**RECONSTRUCTION OF ENCINA AVENUE
FROM MIDDLEFIELD ROAD TO END**

**COUNTY PROJECT NO. RW703
PROJECT FILE NO. E5044000**

ADDENDUM NO. 1

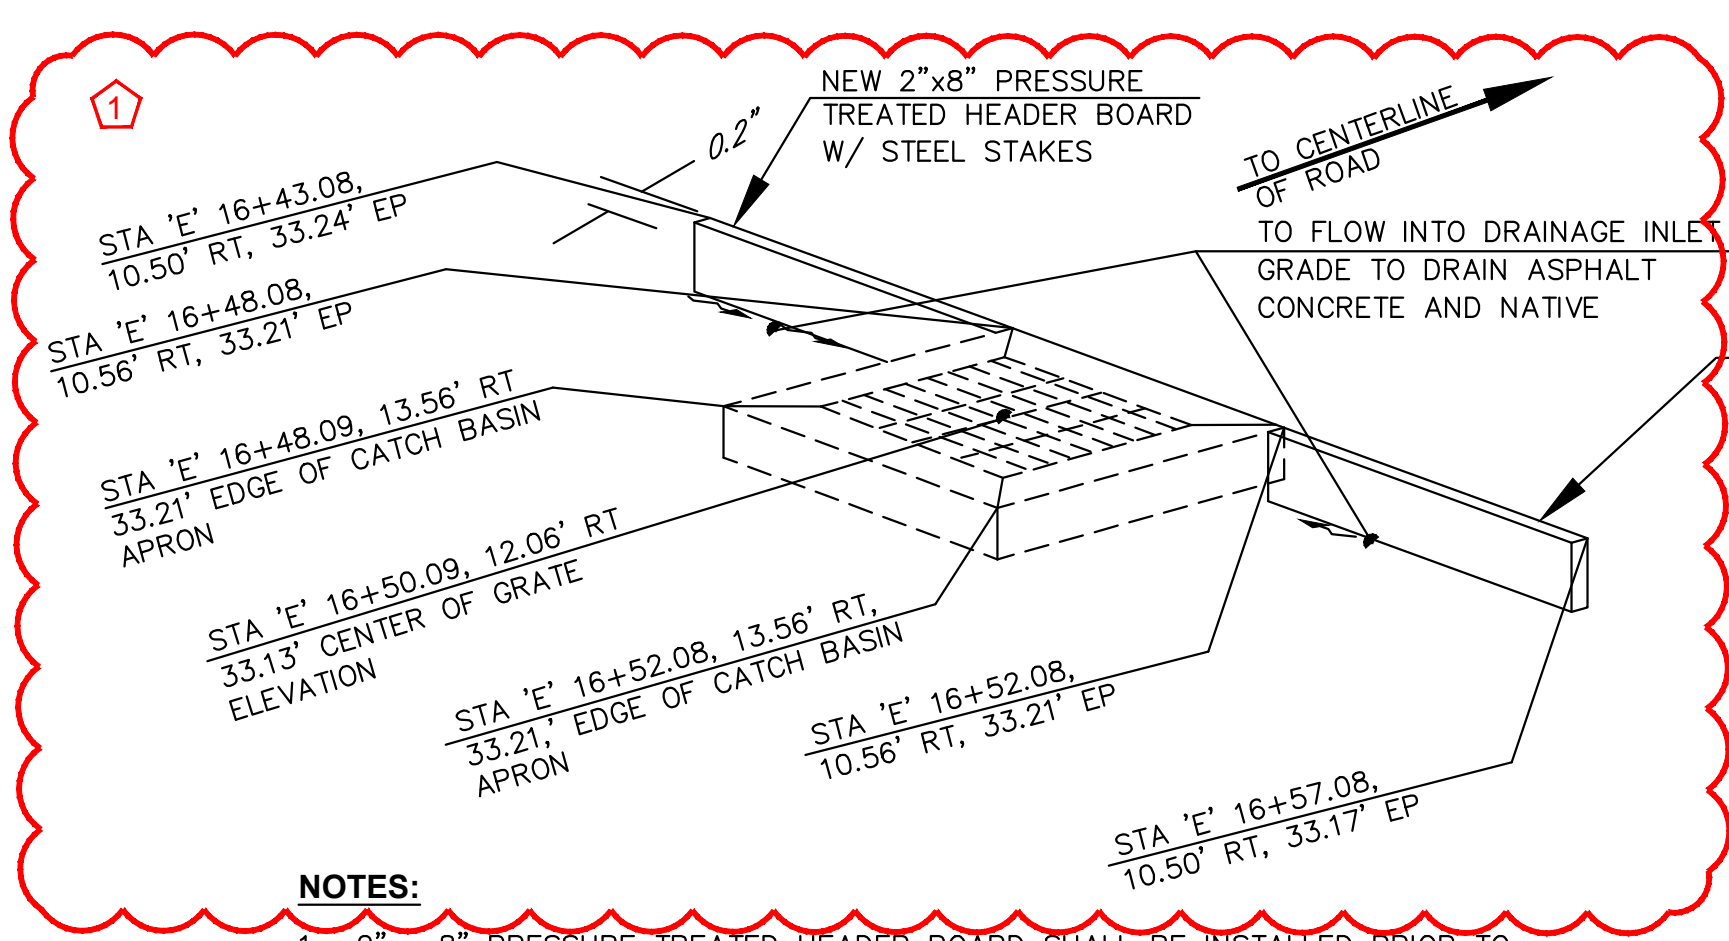
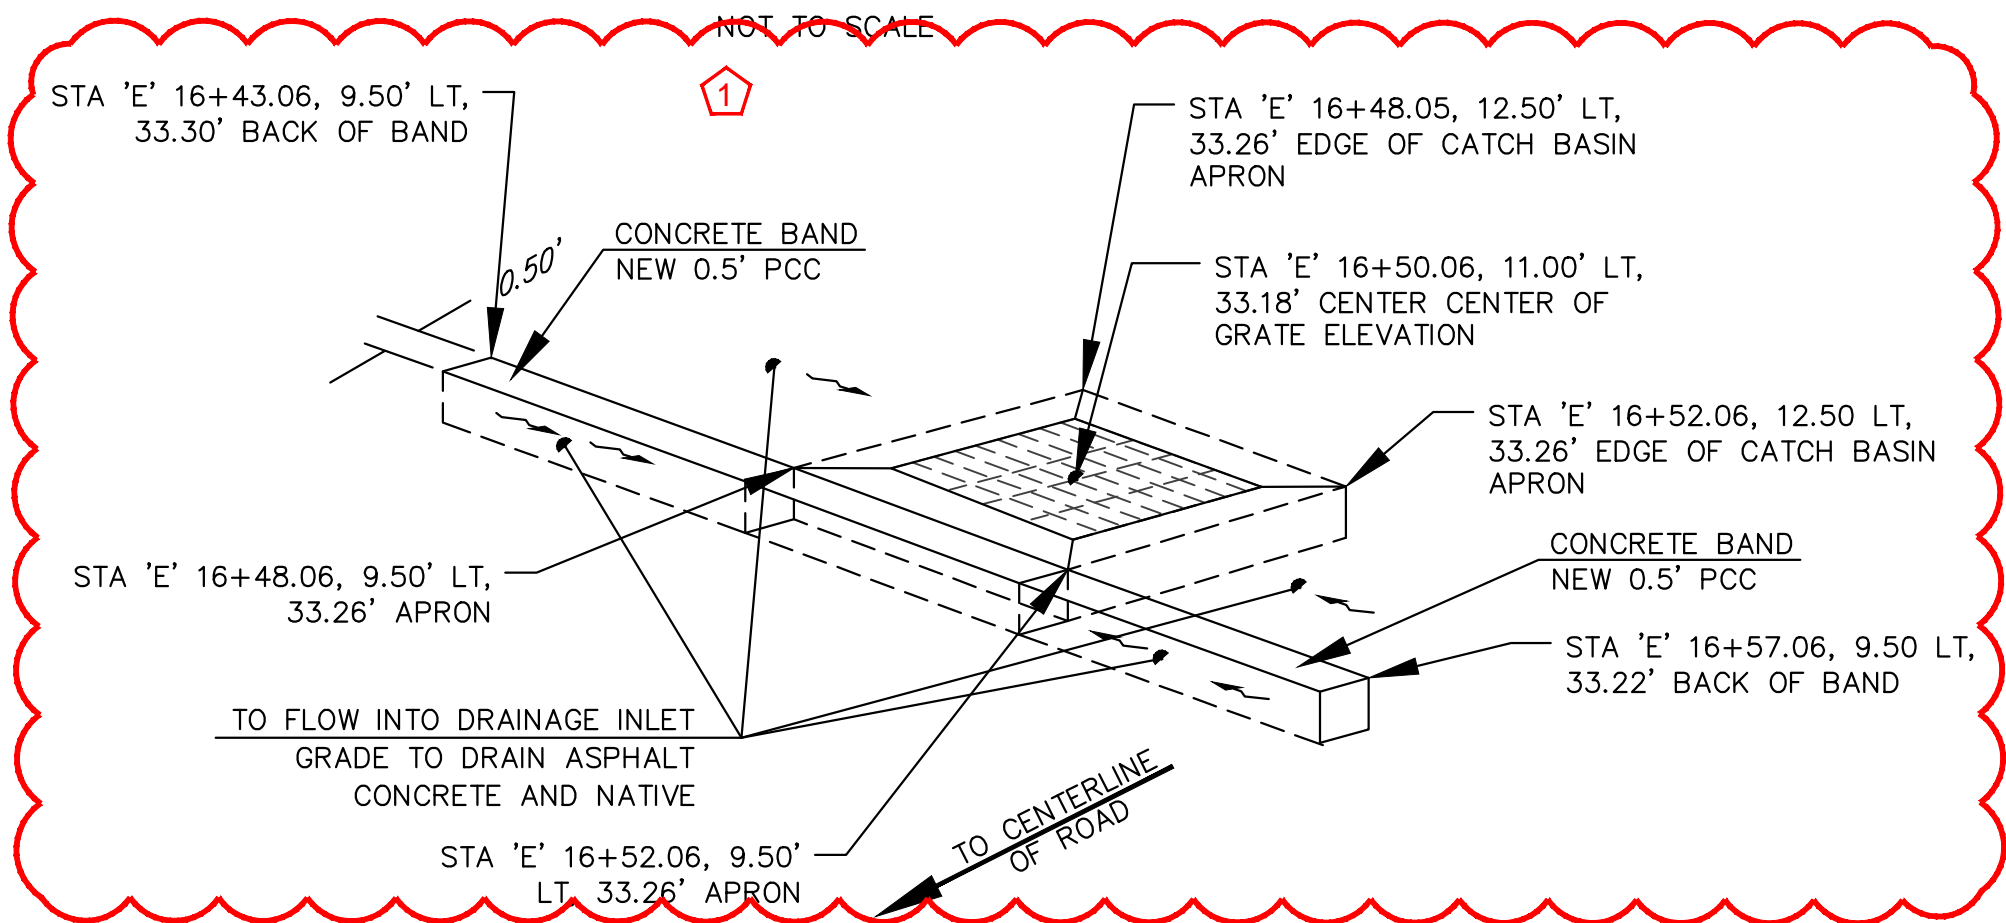
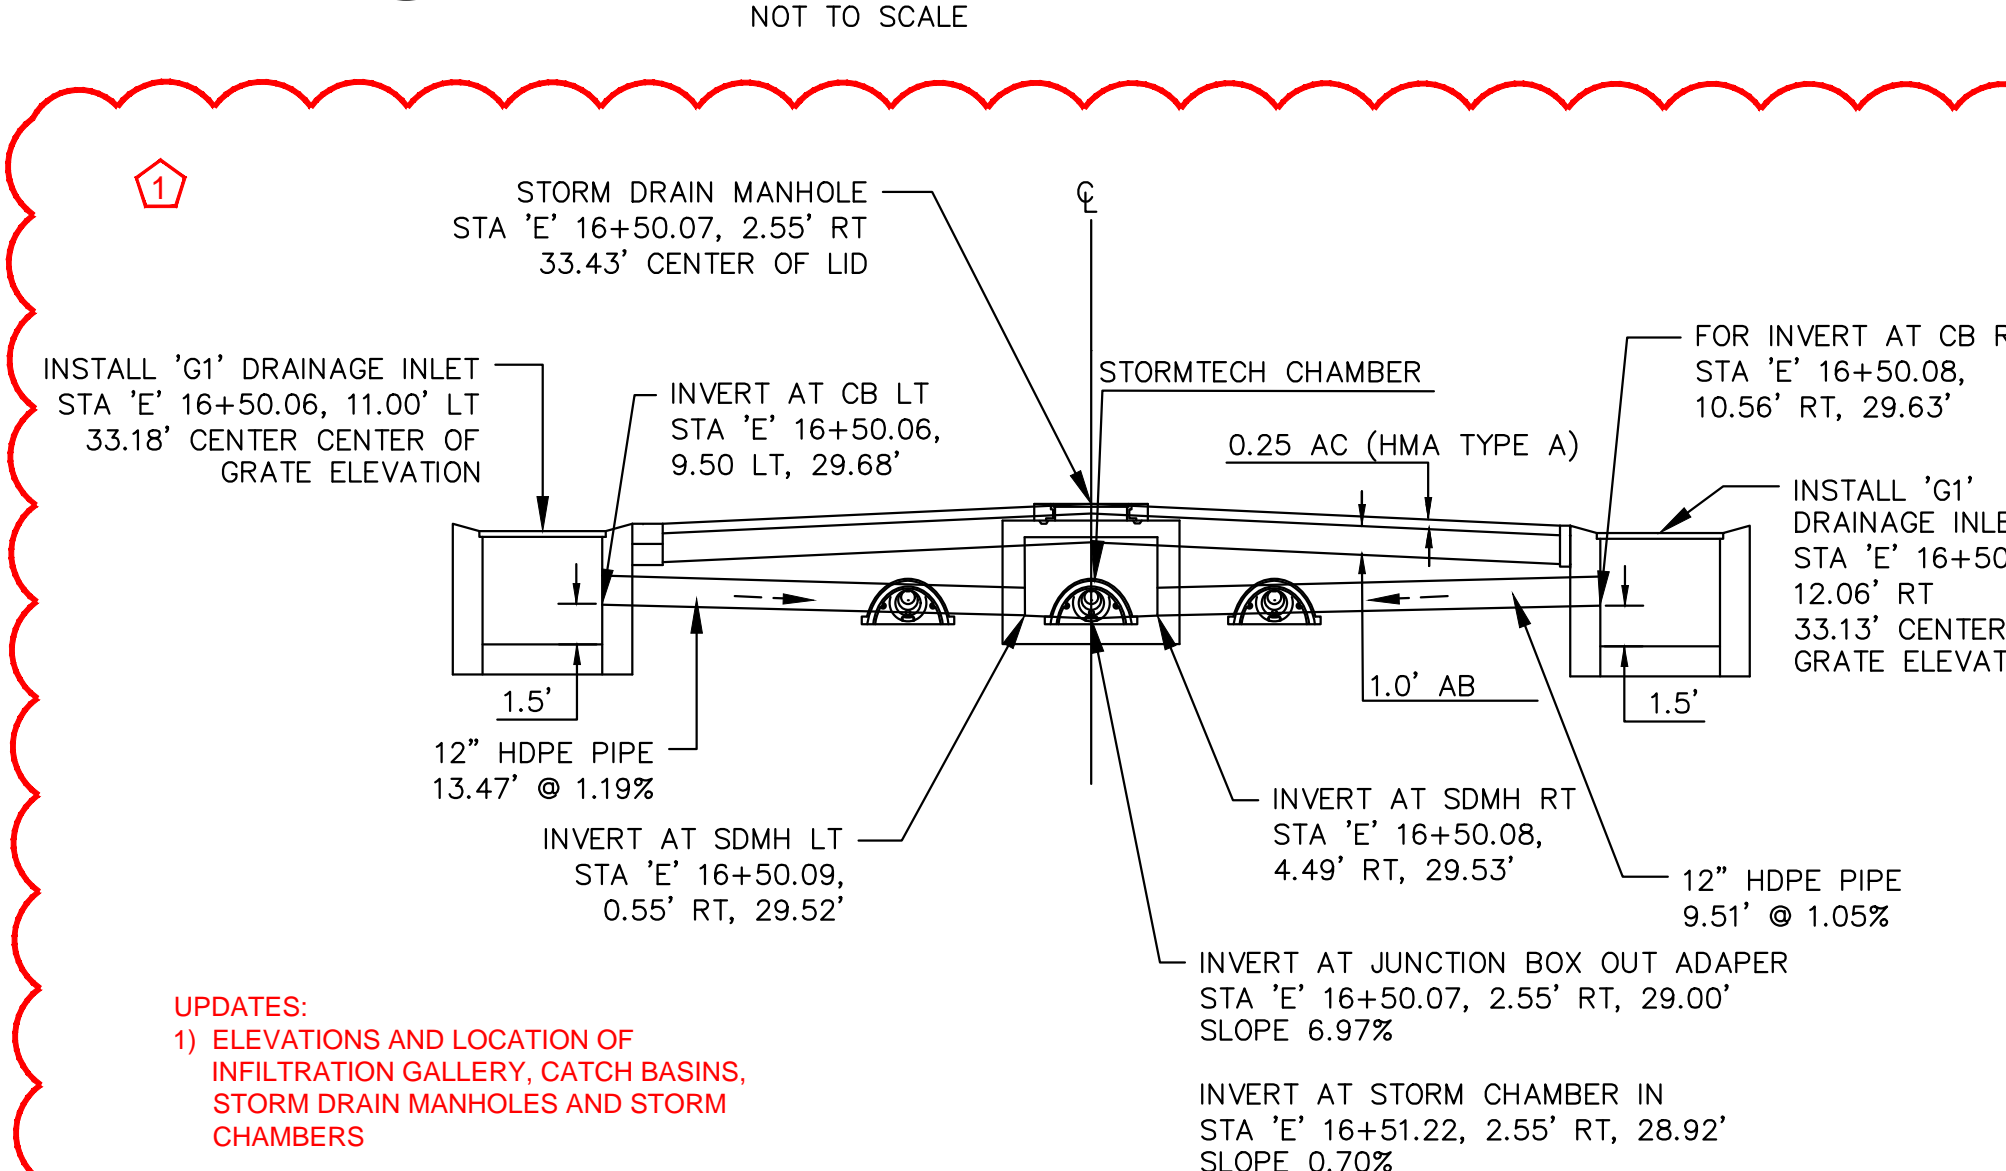
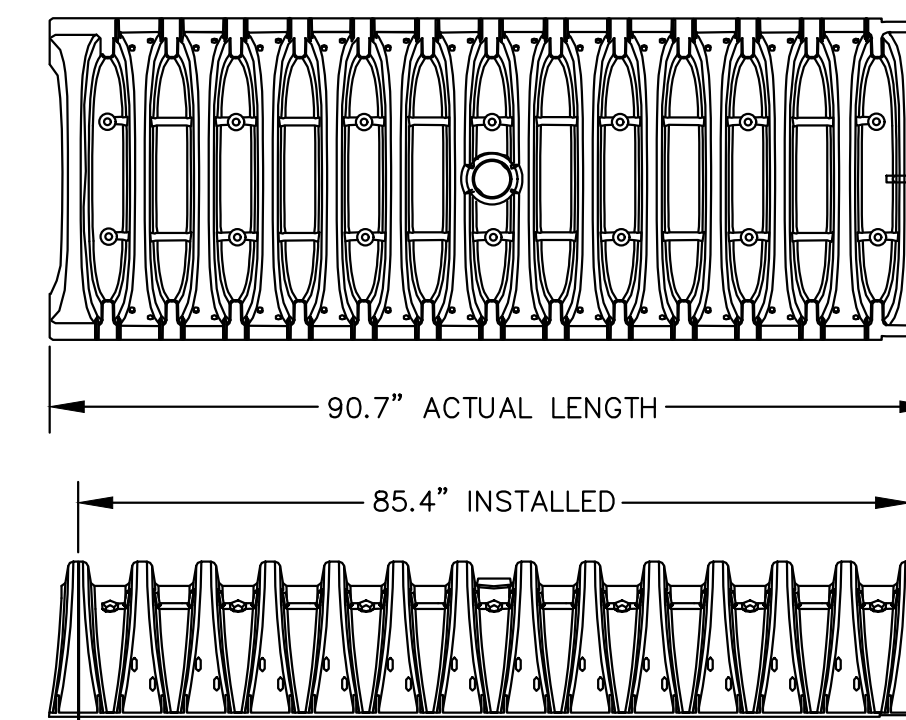
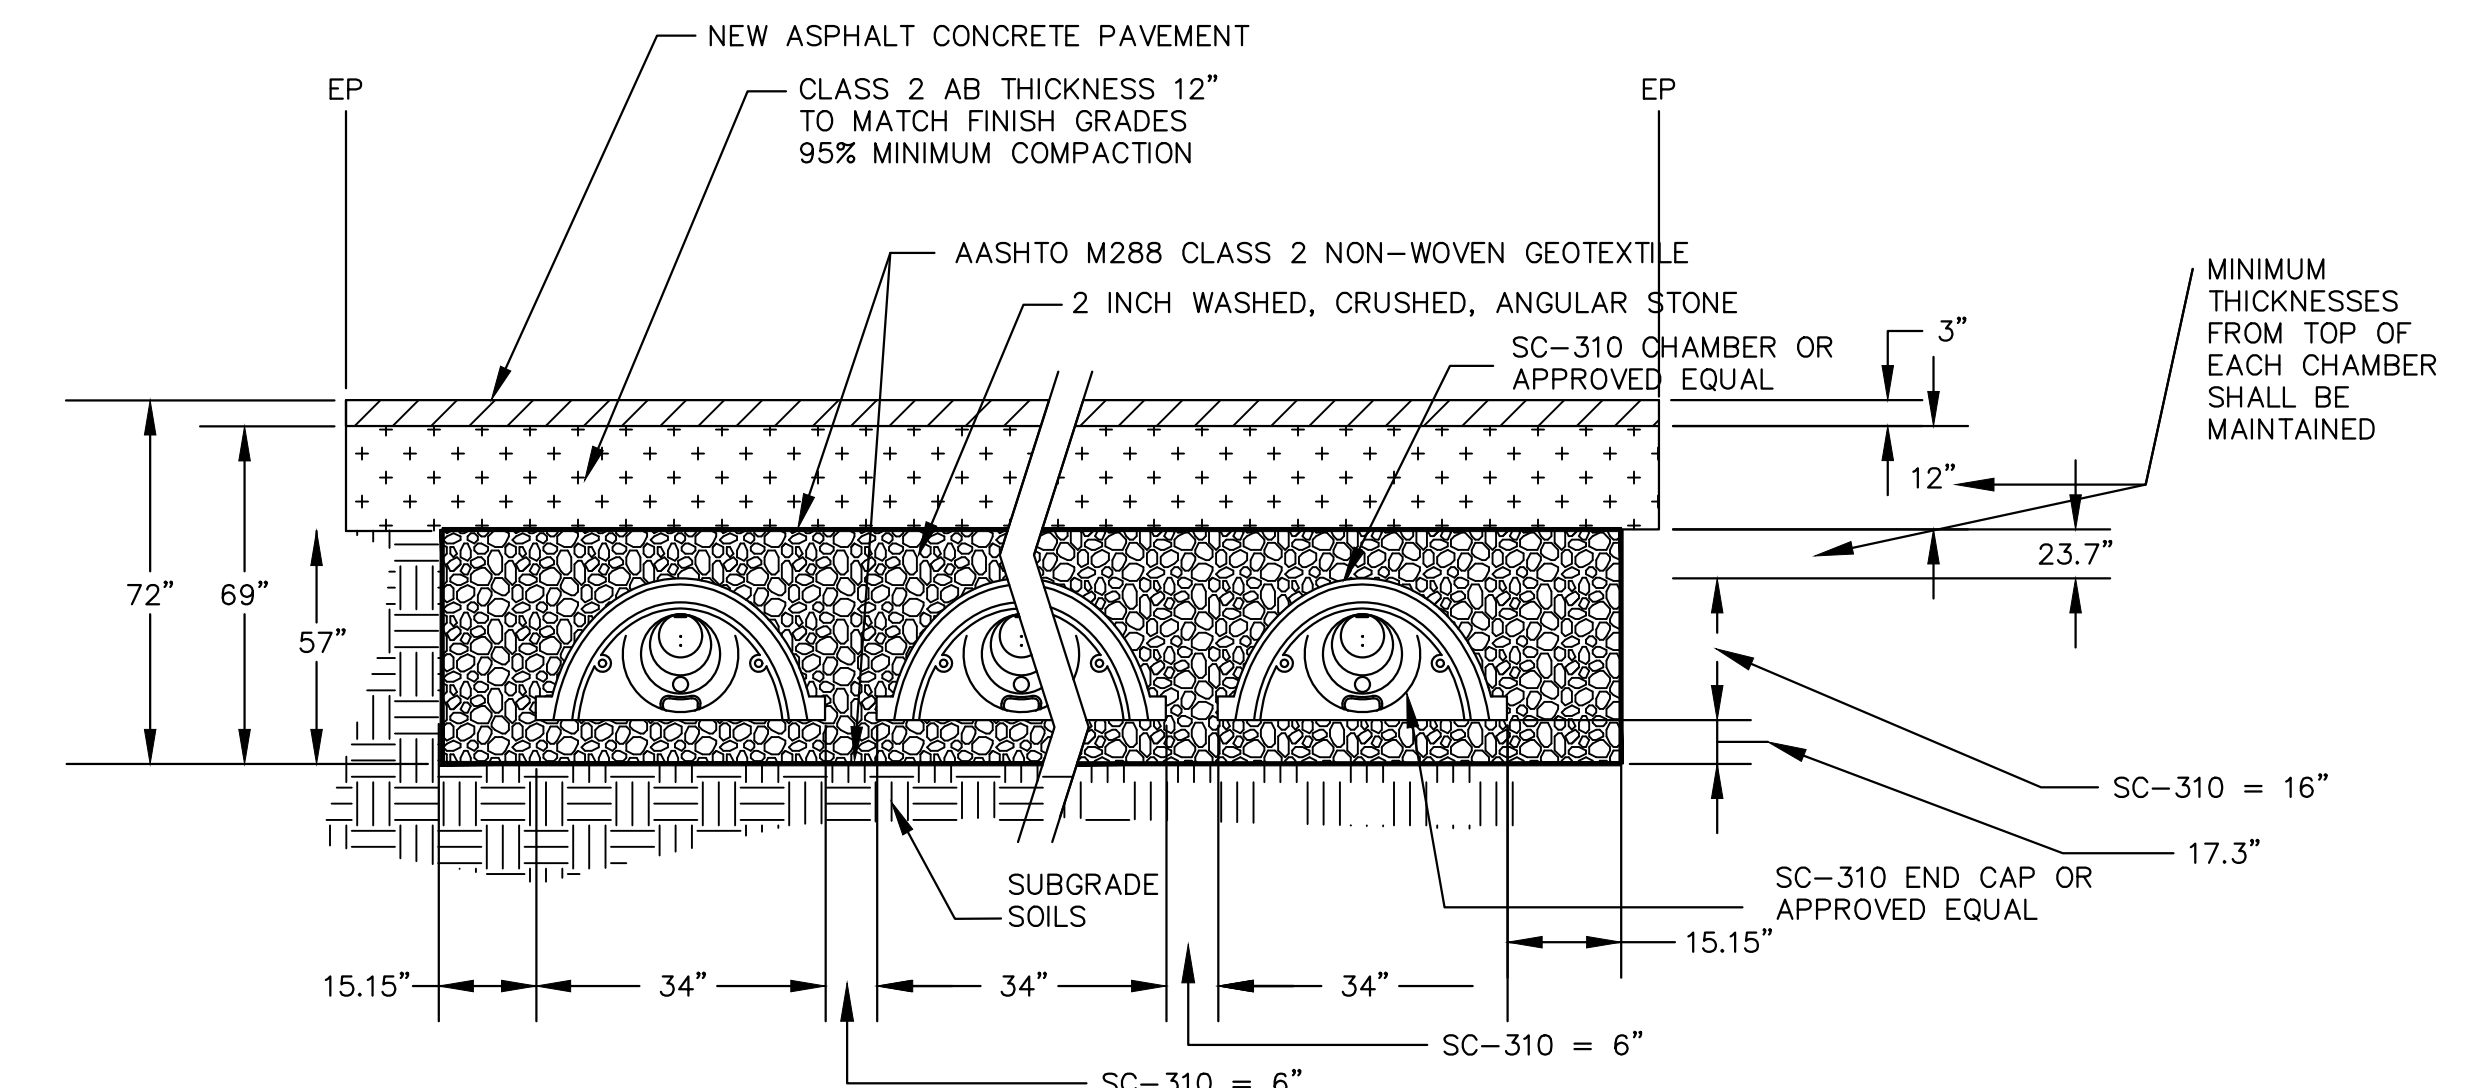
- UPDATES:**
1) ELEVATIONS AND LOCATION OF INFILTRATION GALLERY, CATCH BASINS, STORM DRAIN MANHOLES AND STORM CHAMBERS
